Access Compliance Report

Public Rights-of-Way

(Curb Ramps)

Intersection ID: 18778	Main Street: E_INDEPENDENCE_BV	Cross Street: E_W_T_HARRIS_BV	Location: W
ADA ID: 89B31244190B	Ramp Type: BlendTrans2	Initial Pass/Fail: Pass	Overall Compliance: No
		Severity Score: 0

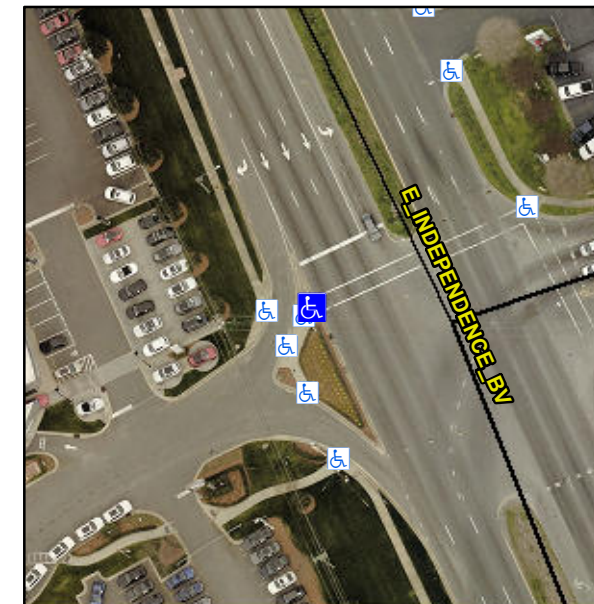
Compliance	Description	Data	Compliance	Description	Data
N/A	Ramp Length (in)	52.0	Yes	BlendTrans Slope (%)	0.5
Yes	Ramp Width (in)	48.0	Yes	BlendTrans XSlope (%)	1.7
N/A	Flare Type LT	Sloped	N/A	Flare Type RT	Sloped
N/A	Flare Slope LT (%)	2.0	N/A	Flare Slope RT (%)	7.4
N/A	Flare Traversable LT?	No	N/A	Flare Traversable RT?	No
N/A	Landing Length (in)	N/A	Yes	DWS Provided?	Yes
N/A	Landing Width (in)	N/A	Yes	DWS Contrast?	Yes
N/A	Landing Slope (%)	N/A	Yes	DWS Length (in)	24.5
N/A	Landing X Slope (%)	N/A	Yes	DWS Full Width?	Yes
N/A	Landing Curb? (Y/N)	No	Yes	DWS Offset (in)	0.5
N/A	Shared Landing?	No			
Yes	Gutter Ponding?	No	Yes	Gutter Slope (%)	2.6
Yes	Gutter Lip Ht (in)	0.0	Yes	Gutter X Slope (%)	2.5
N/A	Painted X Walk1?	Yes	N/A	Painted X Walk2?	N/A
	X Walk 1 Direction	To NE		X Walk 2 Direction	N/A
	X Walk 1 Width (in)	87.0		X Walk 2 Width (in)	N/A
	X Walk 1 Slope (%)	2.8		X Walk 2 Slope (%)	N/A
	X Walk 1 X Slope (%)	2.7		X Walk 2 X Slope (%)	N/A

Yes	Ramp inside XWalk1?	Yes	N/A	Ramp inside XWalk2?	N/A
	Road Slope (%)	2.7		Clear Space?	Yes
	Road X Slope (%)	2.8	N/A	Clear Space to XWalk (in)	N/A
Yes	Any Obstructions?	No	Yes	Storm Grate/Utility Hazard?	No
	Obstruction Type			Storm Grate/Utility Type	
		N/A			N/A
			Yes	Surface Condition? (G/P)	Good
			No	Curb Slope (%)	18.2

Remove & Replace Curb Slope and Extend Ramp.
